**AGENDA
CITY OF CREVE COEUR
BOARD OF ADJUSTMENT
CITY COUNCIL CHAMBER
OCTOBER 20, 2022
4:00 PM**

APPLICATION TO THE BOARD OF ADJUSTMENT
#22-12472 VARIANCE REQUEST FOR THE PROPERTY AT 12472 MEADOW
GREEN PLACE TO RECONSTRUCT AN EXISTING REAR DECK
ENCROACHING 27 FEET INTO THE REQUIRED REAR YARD SETBACK OF 30
FEET

#22-871: VARIANCE REQUEST FOR THE SUBDIVISION AT 871 NORTH MASON ROAD TO DISTURB 2,930 SQUARE FEET, OR 1%, OF THE REQUIRED UNDISTURBED STREAM BUFFER IN ORDER TO REMOVE EXISTING STRUCTURES AND REGRADE THE STREAM BUFFER

Figure 2: Close-up of the Applicants Site Plan showing the deck.

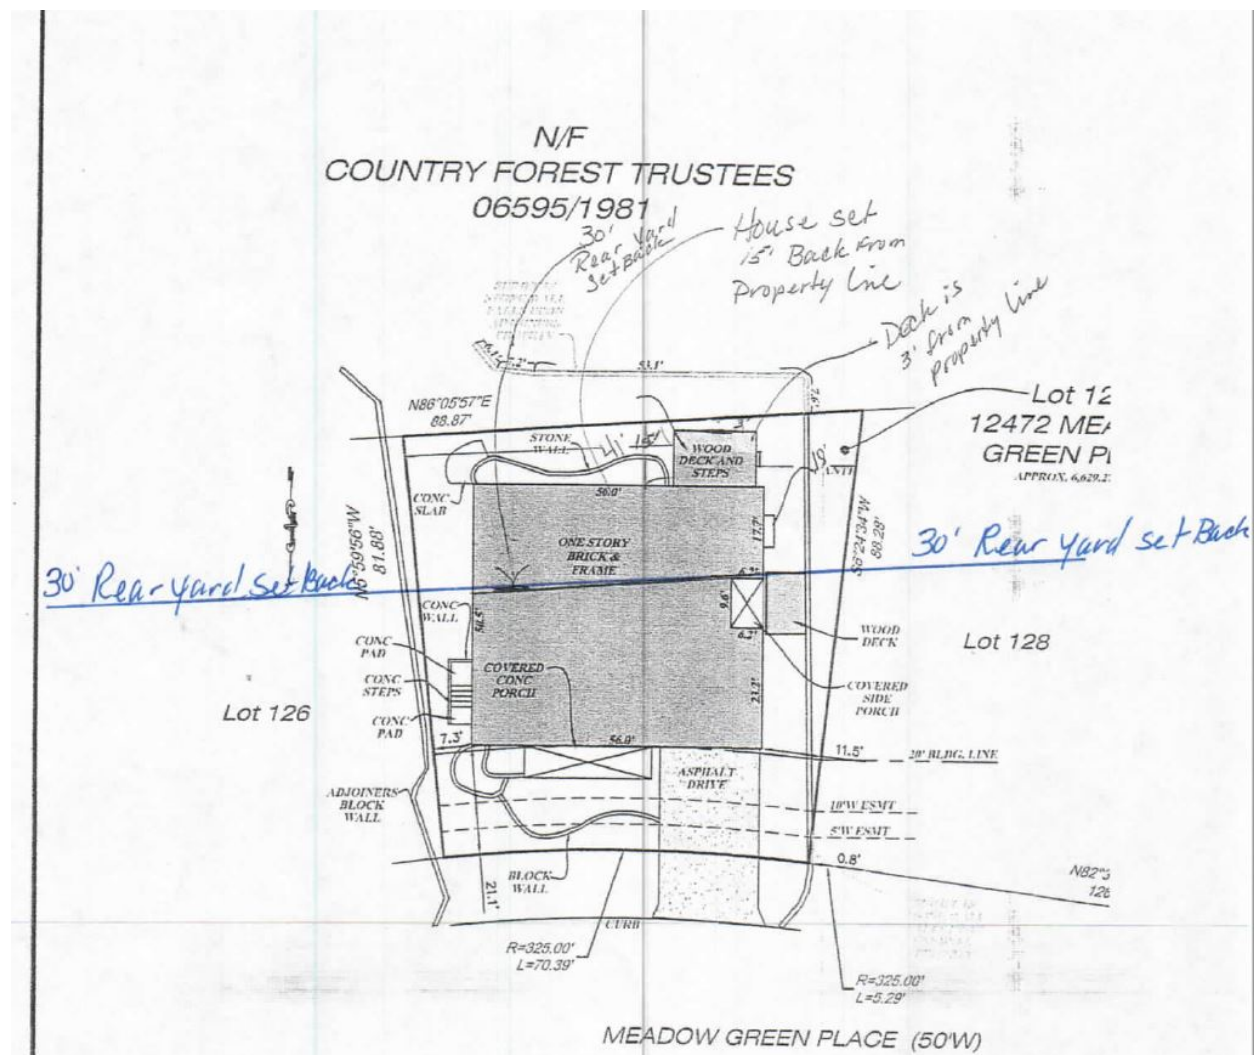
The Applicant is seeking a variance to allow for a new deck within the rear yard setback with the same dimensions as the existing deck. This puts the deck 3 feet from the rear property line, where a deck may only project up to 5 feet into the 30-foot setback, thus the deck must be a minimum of 25 feet from the rear property line. The variance request is for the remaining 22 feet of encroachment into the rear yard setback.

Figure 3: Close-up of the proposed overhead view of the deck.

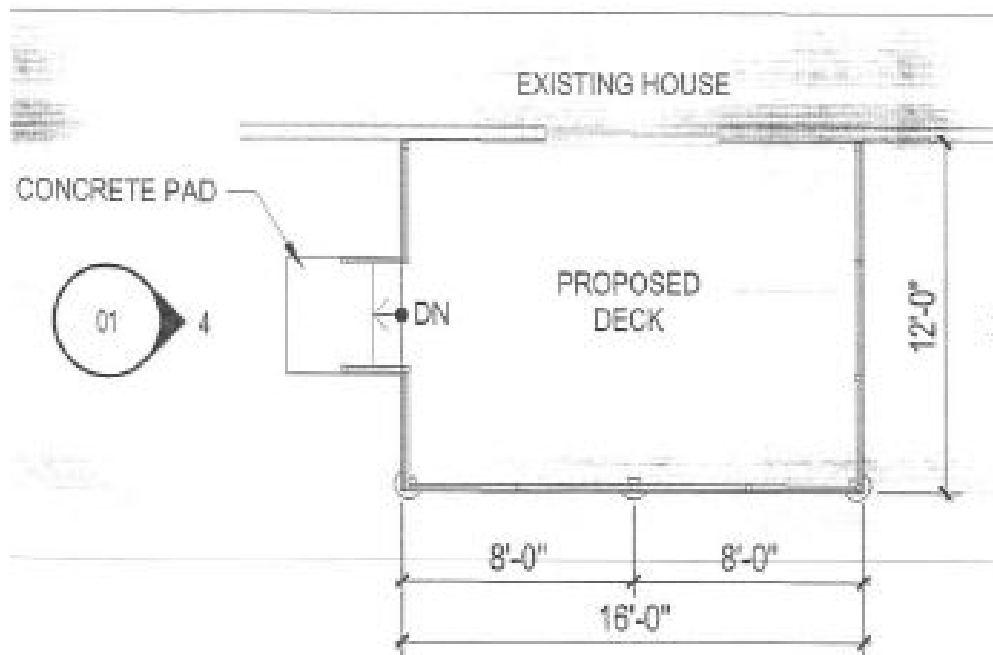
Given that the request does not extend the depth of the existing rear deck, it is unlikely that the average viewer will perceive a negative impact arising from a sense that the deck is too close to the public common ground compared to those around it. The homeowner has enjoyed the construction of the deck in the same footprint for many years without any adverse effect to adjacent property owners or residents. Further, if the members of the Board believe that the aesthetic qualities of the deck are in keeping with the rest of the house, and the neighborhood in general, it is likely that allowing the deck will not have an adverse effect on the adjacent properties, as many of the homes have decks that are so similarly situated as can be seen in the GIS image as shown on the last page of this report.

Figure 2: Site Plan with storm buffer disturbance areas highlighted in yellow.

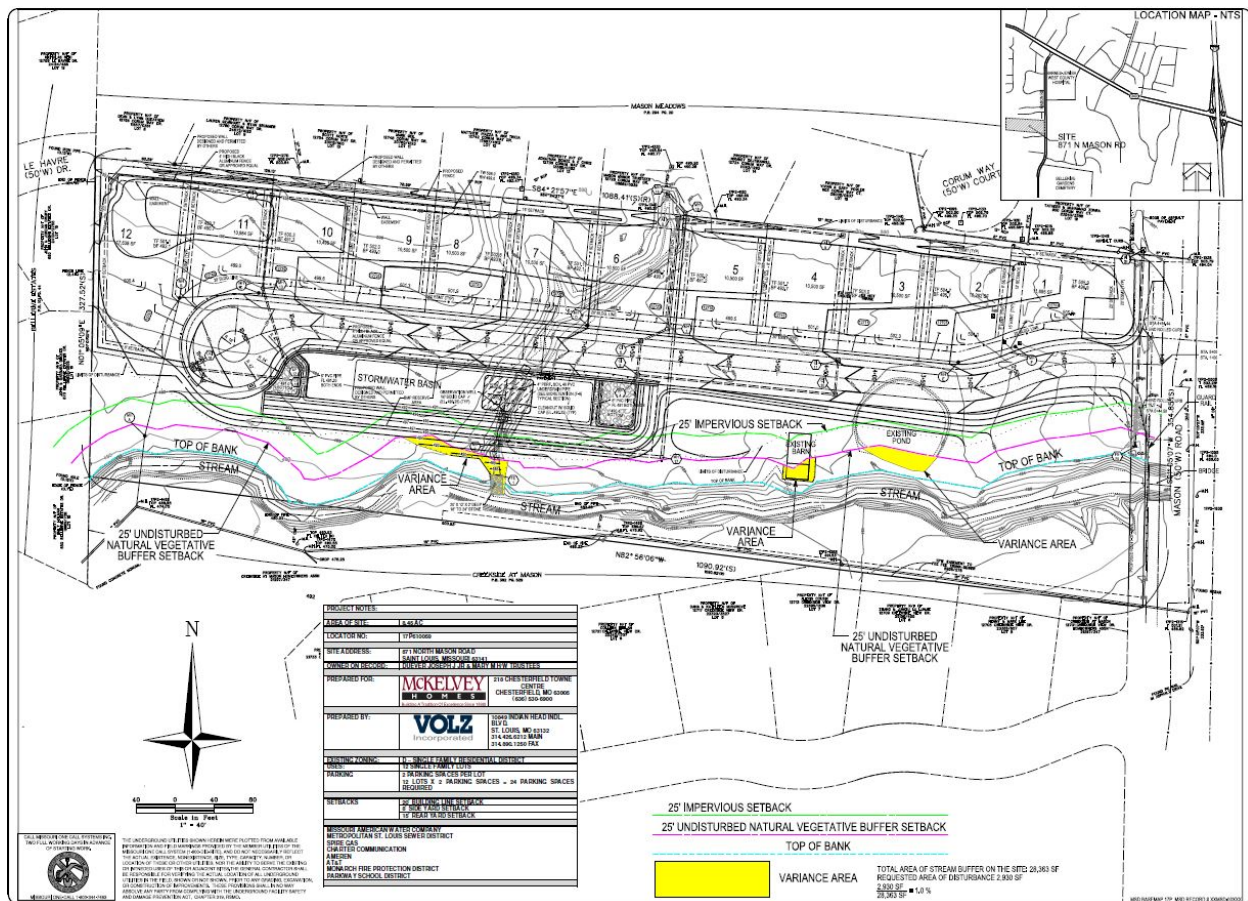
The stream buffer requirements restrict the use of the land 50 feet on either side of it which significantly limits the use of the property. The provided site plan shows that 2,930 square feet, or 1%, of the 28,363 square foot stream buffer will be disturbed for the demolition of the pond and barn and installation of the on-site stormwater basin before being returned to a natural vegetative buffer area. The location of the pond limits the location of the cul-de-sac access road, which has to reach all the way to the western portion of the lot. Moving the cul-de-sac to avoid the pond all together would eliminate 3-4 of the proposed lots. With the proposed variance, the applicant is already proposing a single loaded street with 1/3 the allowed density for the "D" Zoning District and, according to the applicant, the elimination of additional lots would create a project that is not economically feasible.

The stormwater basin has to be located at the lowest portion of the site near the creek in order to treat the onsite water. The submitted plan shows that once the demolition of the barn is complete, the pond is filled in and the stormwater basin is constructed, the 50-foot stream buffer will be returned to a natural buffer without impervious area or additional grading. After reviewing the proposed variance request and submitted site plan, Public Works Staff is not concerned that the variance request will have a negative

“I move to approve a variance allowing for the disturbance of 2,930 square feet, or 1%, of the required 25-foot storm buffer, subject to post-construction restoration of the storm buffer ground, in order to construct a 12-lot subdivision with access road and on-site storm water basin at 871 N. Mason Road in the “D” residential zoning district as shown on the submitted site plan prepared by Volz Incorporated on September 12, 2022, based upon a positive finding that factors a-f of Section 430.050(B)(4) have been considered.”
